Design Review Committee

Case File Number: ZP160026

October 26, 2016

Project Location / Assessor's Parcel Numbers:	1431 Jefferson Street 003 007101801 & 003 007101900
Proposal:	To construct an 18-story, 276 room hotel with ground-floor retail and a four-level parking garage above grade.
Applicant/ Phone Number:	Michael Stanton Architecture / (415) 865-9600
Property Owner:	Karan Suri
Case File Number:	ZP160026
Planning Permits Required:	Regular Design Review for new construction.
General & Estuary Plan:	Central Business District
Zoning Districts:	CBD-P, CBD-X
Environmental Determination:	Environmental analysis under review
Property Historic Status:	Non-Historic Property
Service Delivery District:	Metro
City Council District:	3
Action to be Taken:	Conduct design review, make recommendations to applicant & staff
For Further Information:	Contact Case Planner, Mike Rivera at (510) 238-6417, or by email at mrivera@oaklandnet.com

DRAWING TITLE
NORTH ELEVATION - 15TH ST
STATUS
DRG SUBMITTAL AUG 31, 2016

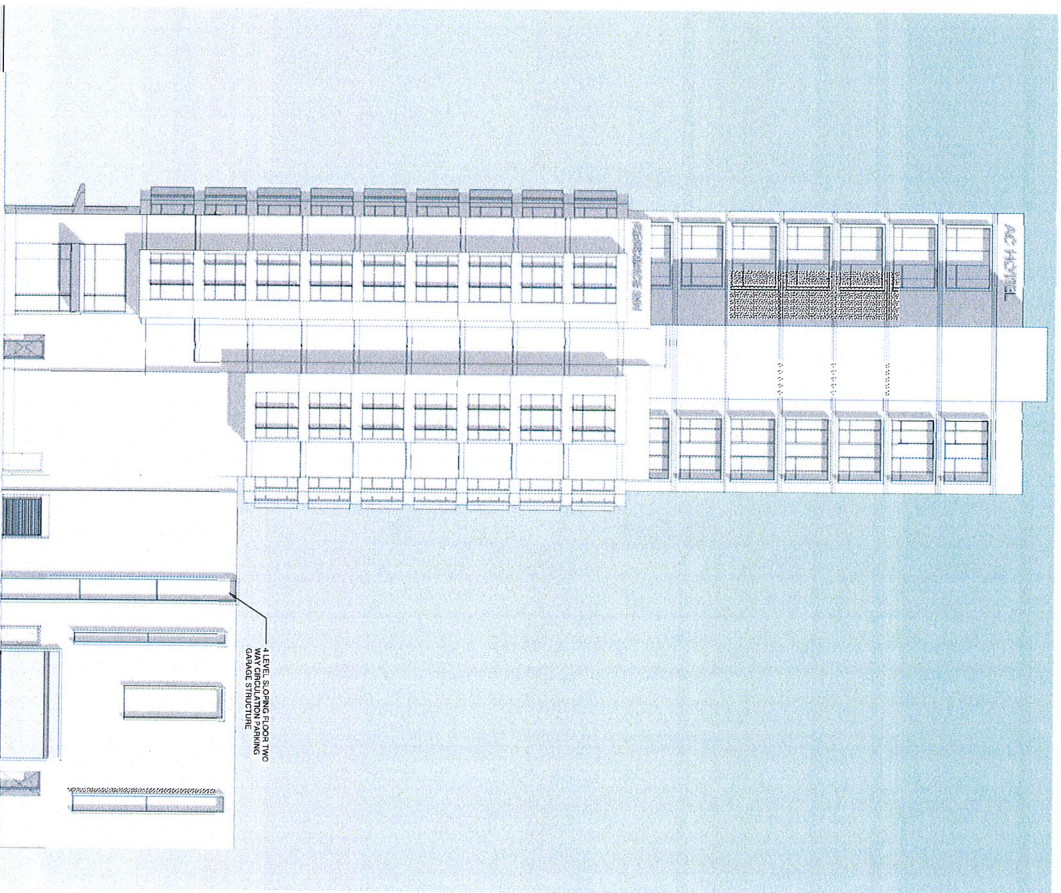
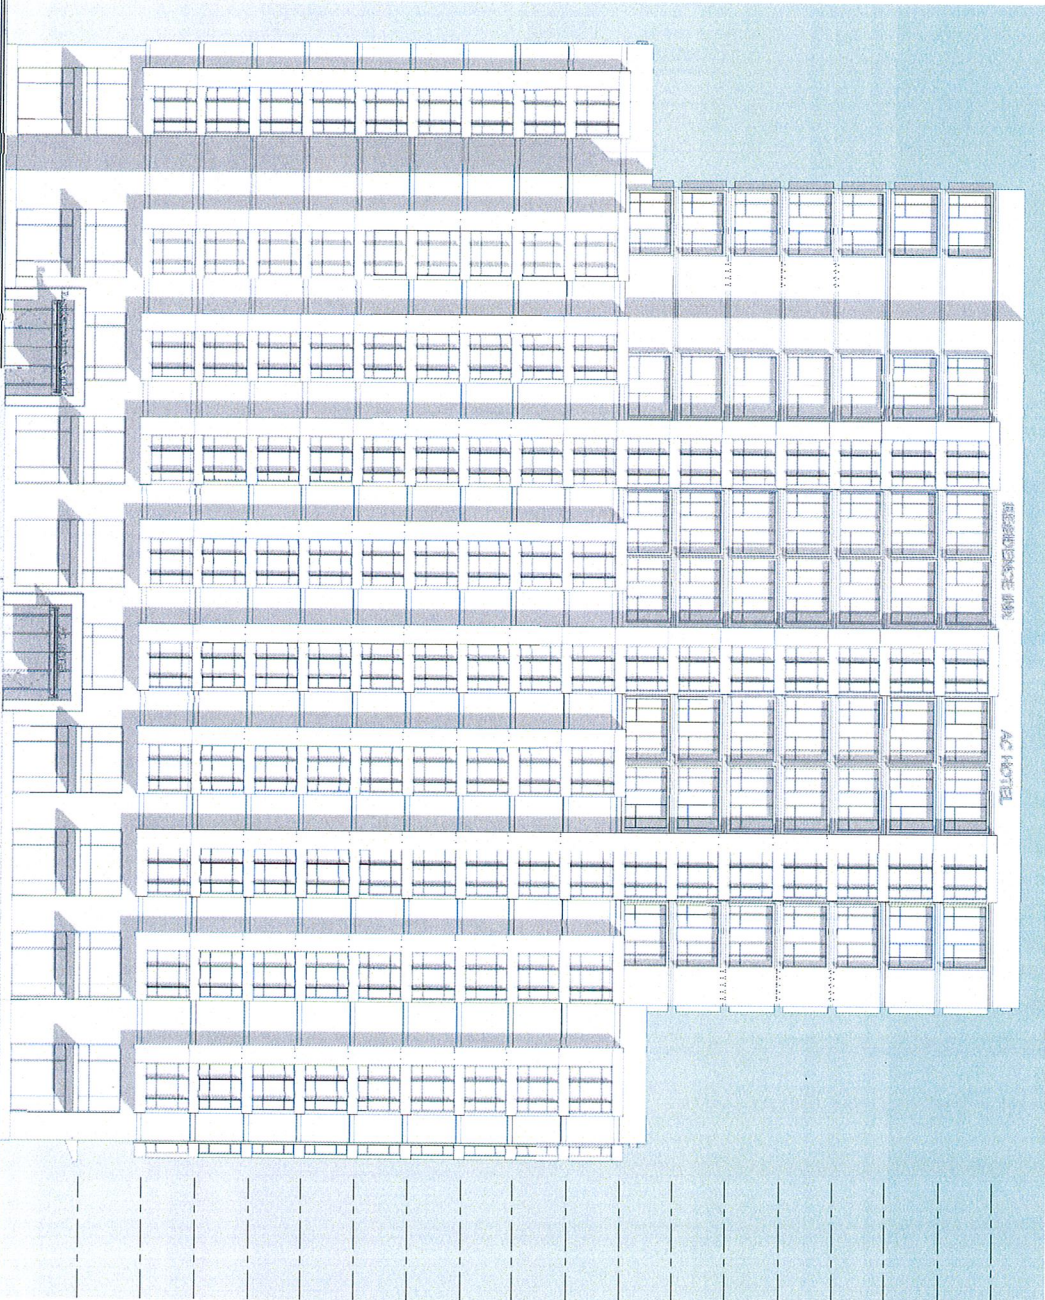
center, office and reception rooms. In addition, staff recommends further development should be made to improve the north side of the exterior building facade on 15th Street.

The proposal meets this standard as the project provides upper story windows on all street-fronting facades. Staff recommends the applicant further explore the installation of other type of window alternatives along the north side of the building to create visual interest. This includes the installation of windows, if feasible, along the west side of the 18-story high-rise building.
